APPLICATION NO.	FILING DATE	FIRST NAMED INVENTOR	ATTORNEY DOCKET NO.	CONFIRMATION NO.
10/714,191	11/14/2003	John Fritsch	12-9540-6520-0000-1	9356
55851 7590 06/15/2007 THE MACLEAN FOGG COMPANY			EXAMINER	
c/o DANA ALI			LAVINDER, JACK W	
1000 ALLANSON ROAD MUNDELEIN, IL 60060-3890			ART UNIT	PAPER NUMBER
•			3677	
	•			
		·	MAIL DATE	DELIVERY MODE
			06/15/2007	PAPER

DETAILED ACTION

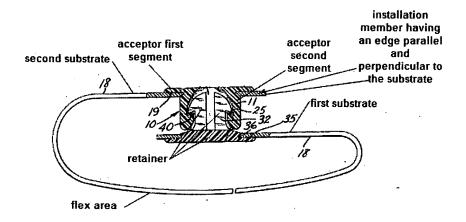
- (b) the invention was patented or described in a printed publication in this or a foreign country or in public use or on sale in this country, more than one year prior to the date of application for patent in the United States.
- 2. Claims 1, 4, 8, 14-16, 18 and 19 have been rejected under 35 U.S.C. 102(b) as being anticipated by Pope, 2610879. Pope discloses a u-nut (has a u-nut shape in cross-section, 11, figure 2) made of plastic including a flex area (18). The term u-nut is considered to carry little weight since the body of the claim fails to refer back to the preamble for meaning. Furthermore, there are no recitations of threads, which are normally found on a nut, or anything else relating to a nut in the body of the claim. Pope also discloses the other limitations of the claimed invention as shown in the annotated figure.

Pope's device is also capable of performing all the functional recitations stated in the claims.
